**ALL PRIME CONTRACTORS MUST ACKNOWLEDGE THIS ADDENDUM.
22A021/9896
SR 534, UNNAMED TRIBUTARY TO CARPENTER CREEK FISH PASSAGE**

UNNAMED TRIBUTARY TO CARPENTER CREEK FISH PASSAGE

ASC 2024 Competition:

Addendum No. 1

ROADWAY SECTION C

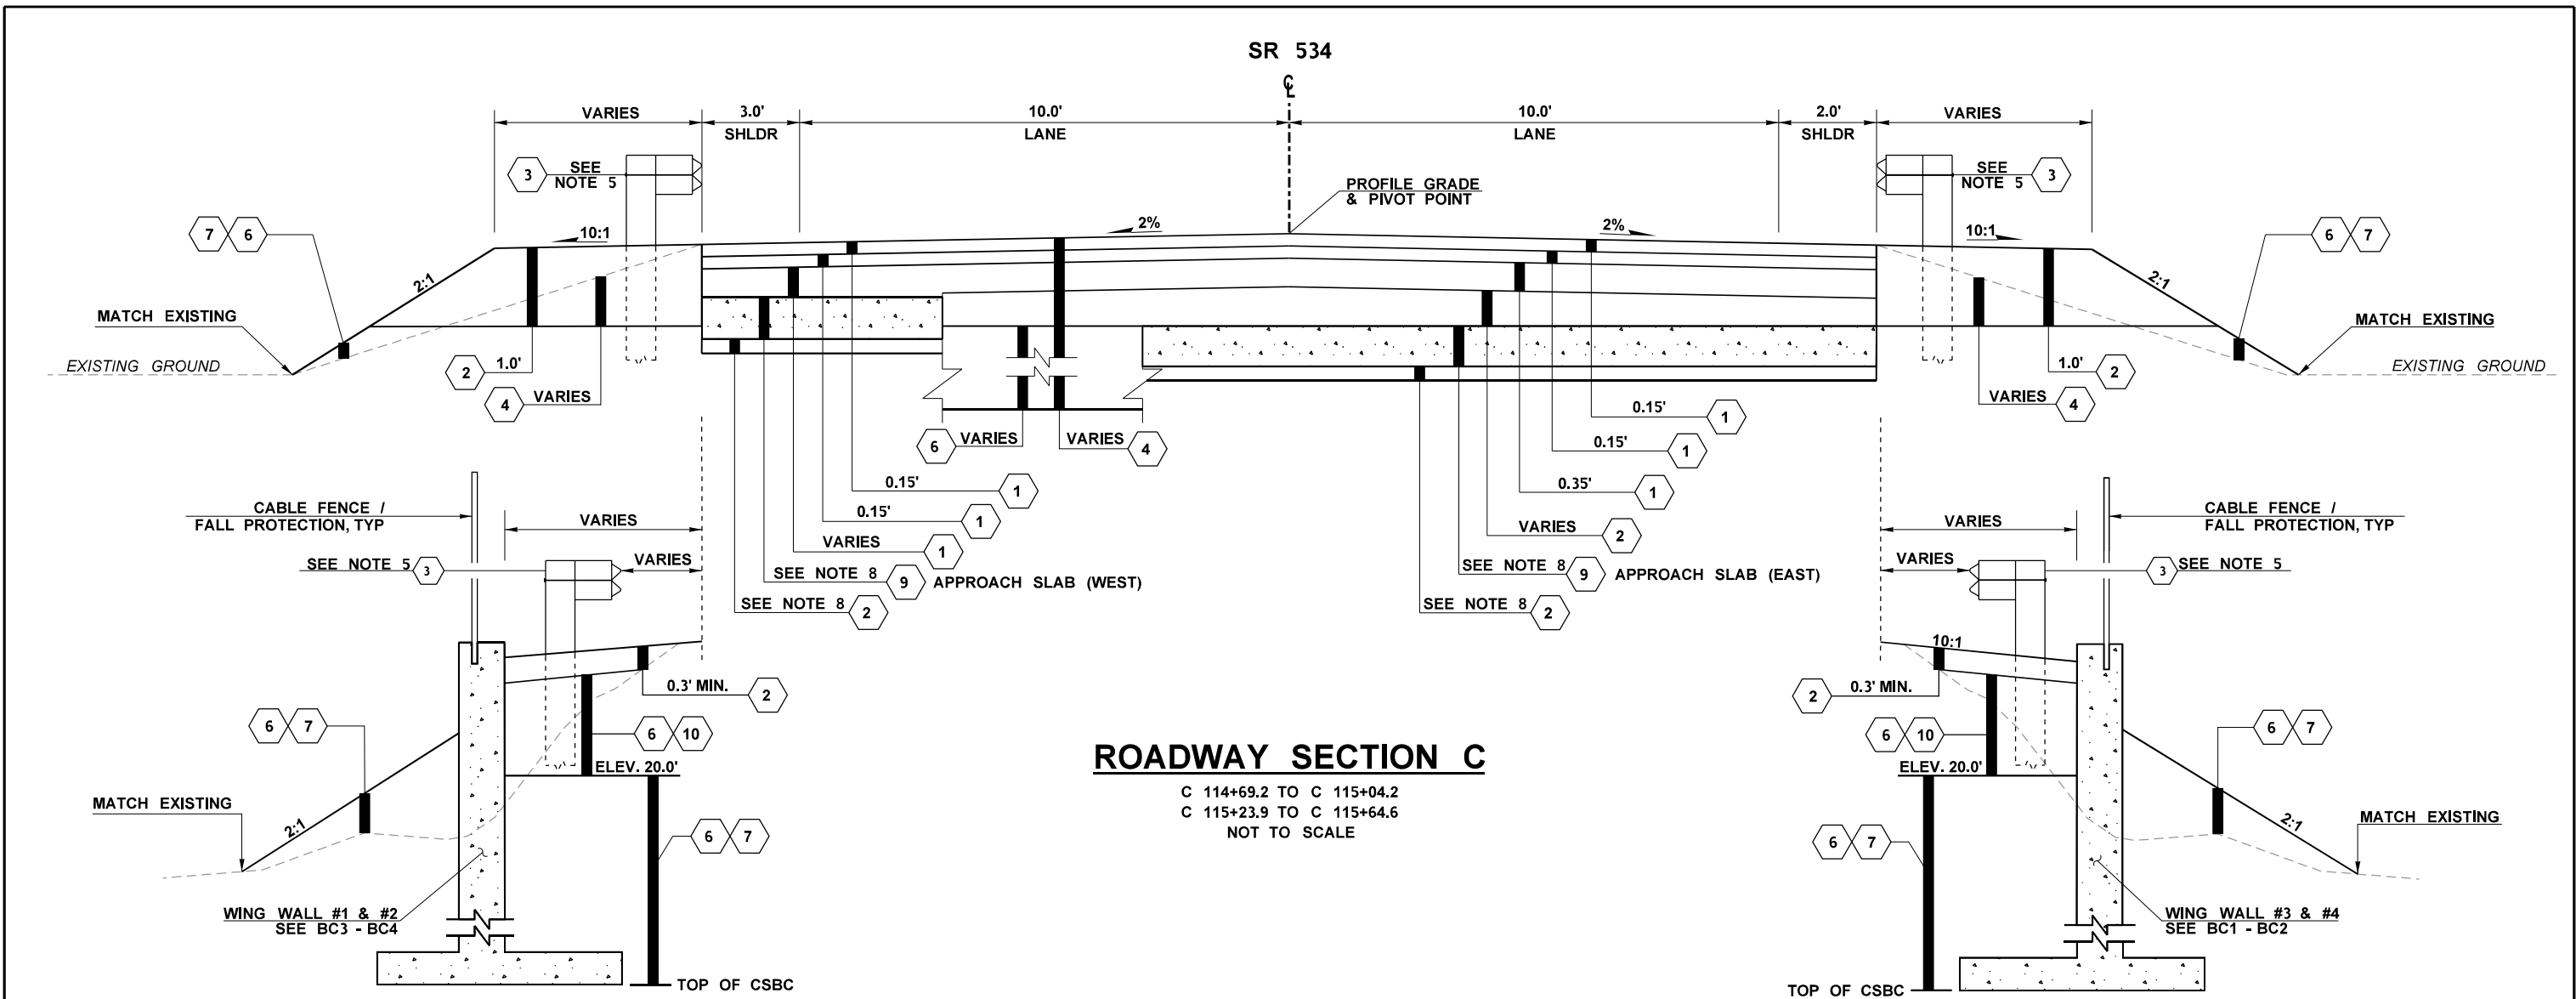
- PRECAST BRIDGE APPROACH SLAB SHALL BE CONTRACTOR DESIGNED IN ACCORDANCE WITH STANDARD PLAN A-40.50, BUT CAN BE REDUCED TO A MINIMUM 20' LENGTH ON THE SHORTEST END AND SHALL BE INSTALLED IN PRECAST SECTIONS. INCLUDED IN THE LUMP SUM BID ITEM "CONTRACTOR DESIGNED BURIED STRUCTURE NO. 1".

- DESIGN OF THE APPROACH SLABS SHALL BE PROVIDED BY THE CONTACTOR IN ACCORDANCE WITH THE STANDARD PLAN A-40.50.

ROADWAY SECTION D

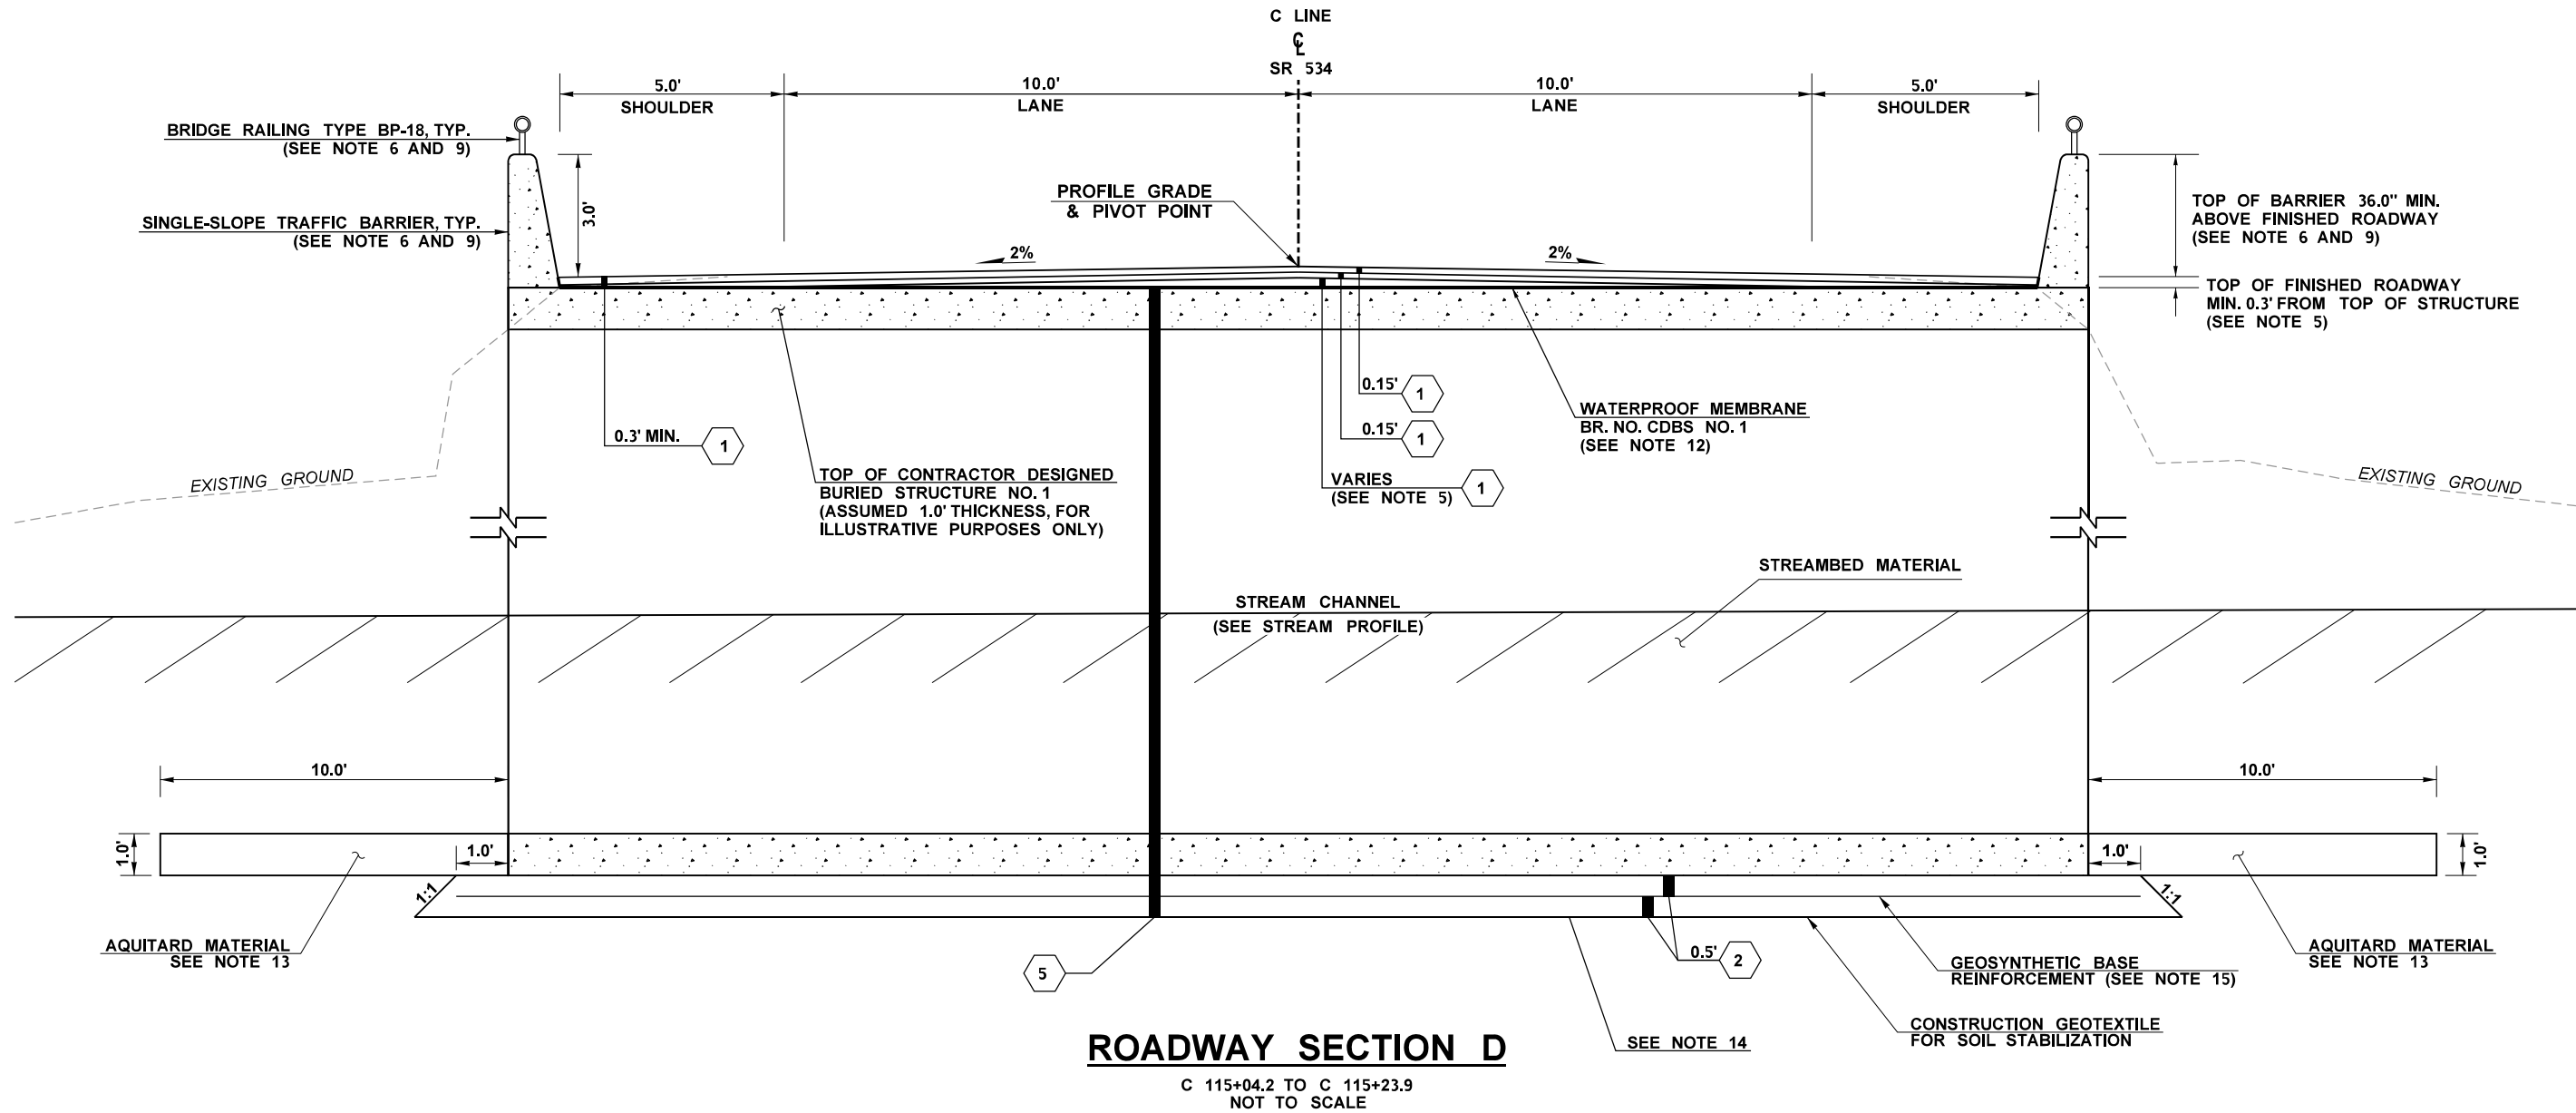
7. INCLUDED IN THE LUMP SUM BID ITEM "EARTHWORK". SEE SPECIAL PROVISIONS.
8. PRECAST BRIDGE APPROACH SLAB SHALL BE CONTRACTOR DESIGNED IN ACCORDANCE WITH STANDARD PLAN A-40.50, BUT CAN BE REDUCED TO A MINIMUM 20' LENGTH ON THE SHORTEST END AND SHALL BE INSTALLED IN PRECAST SECTIONS, INCLUDED IN THE LUMP SUM BID ITEM "CONTRACTOR DESIGNED BURIED STRUCTURE NO. 1".

10. DESIGN OF THE APPROACH SLABS SHALL BE PROVIDED BY THE CONTACTOR IN ACCORDANCE WITH THE STANDARD PLAN A-40.50.

NORTH HEADWALL & WALLS
OUTLET
(LOOKING UPSTREAM)

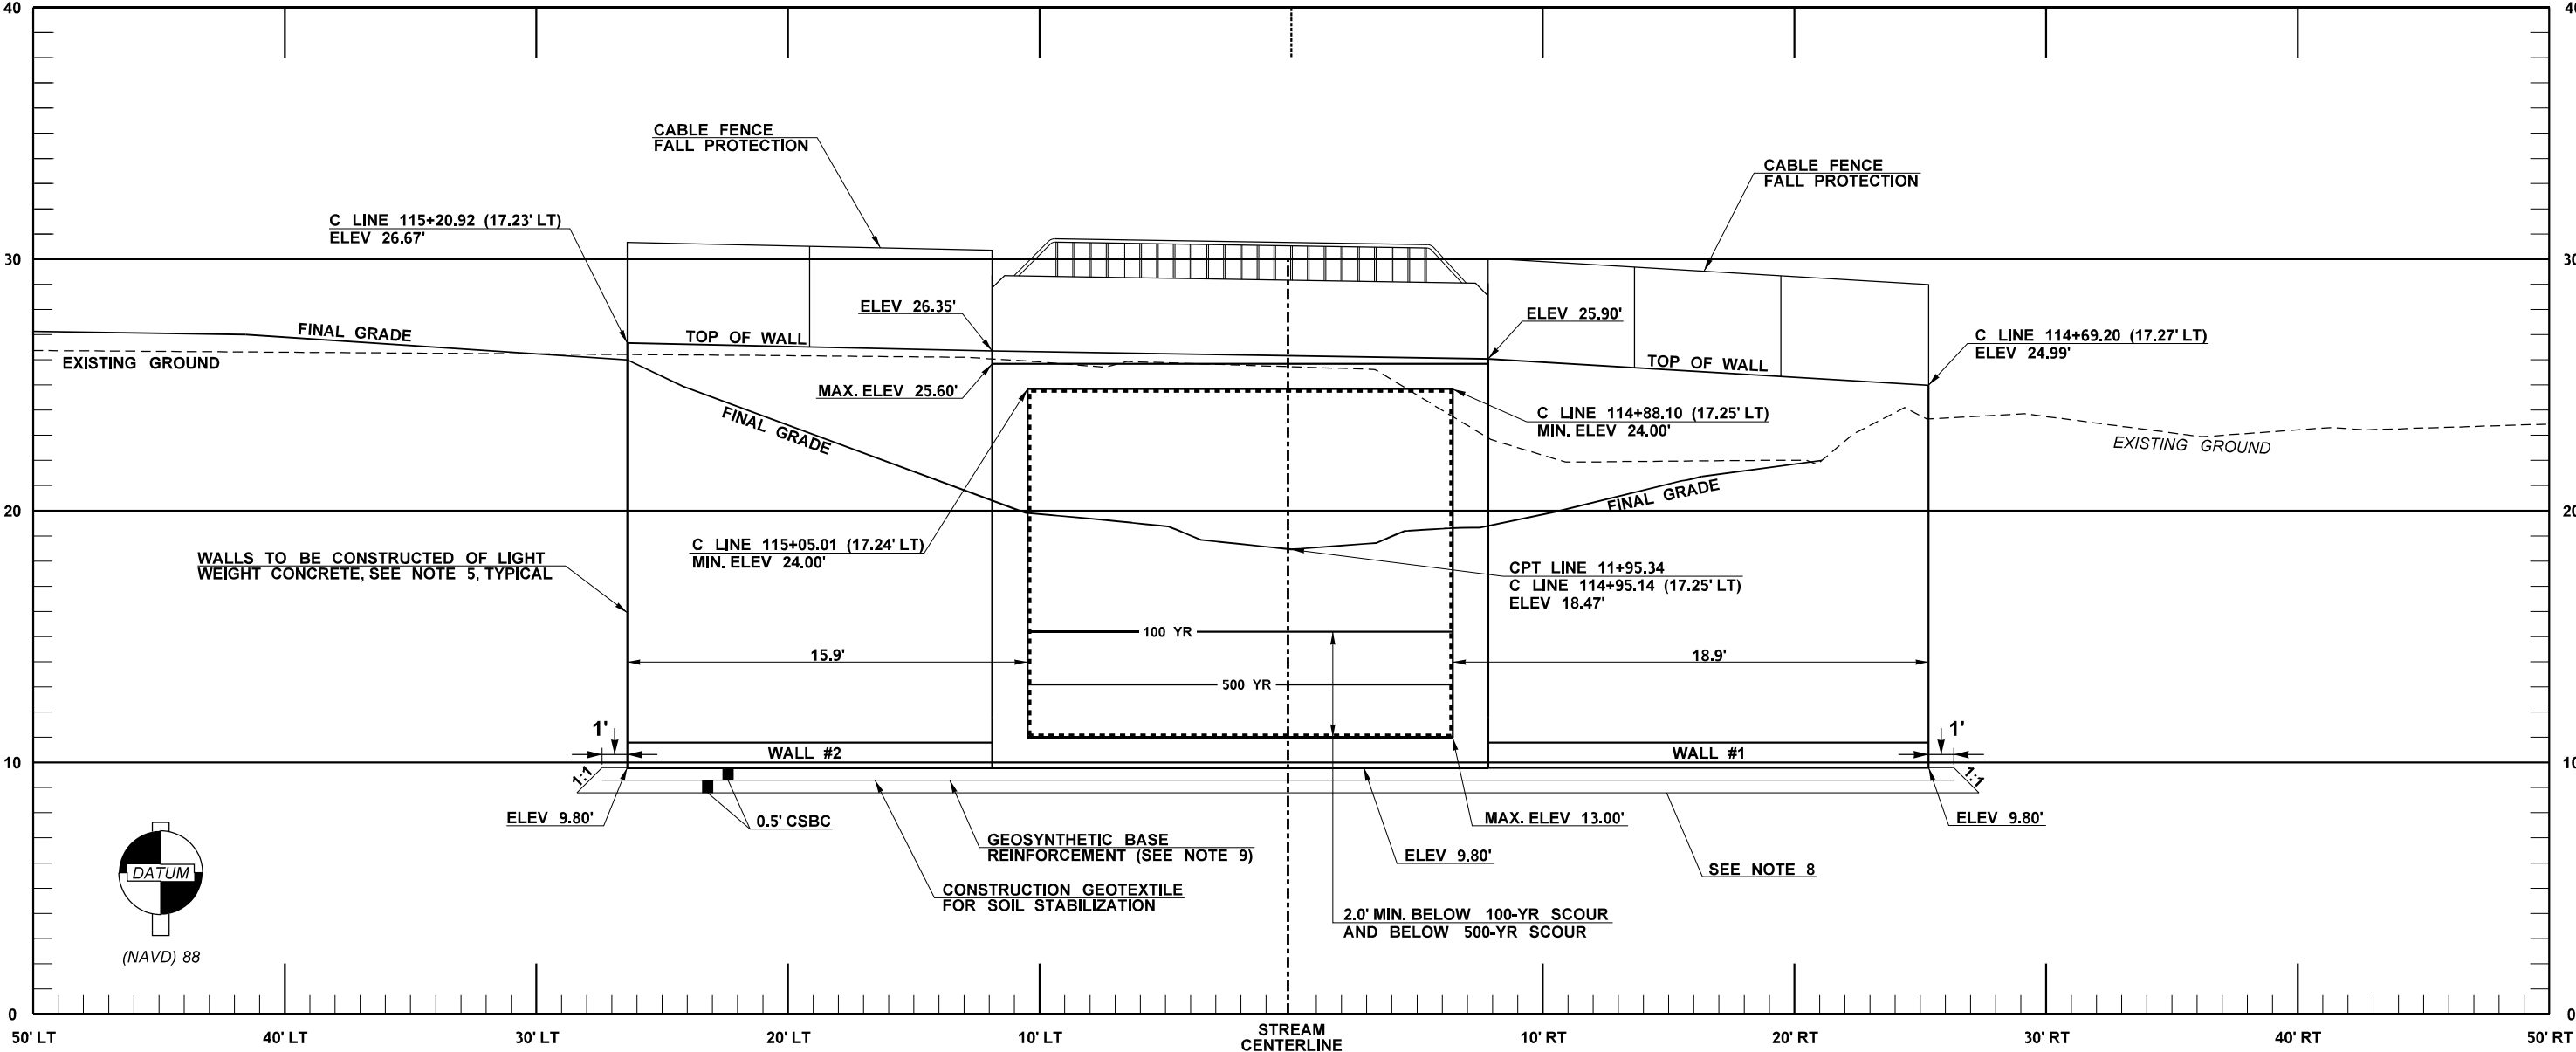
PROJ. ENGR. S. BEIER		AD1 - REPLACEMENT SHEET		11/08/2022		DH																																															
REGIONAL ADM. B. NIELSEN		REVISION		DATE		BY																		SHEET 39 OF 48 SHEETS
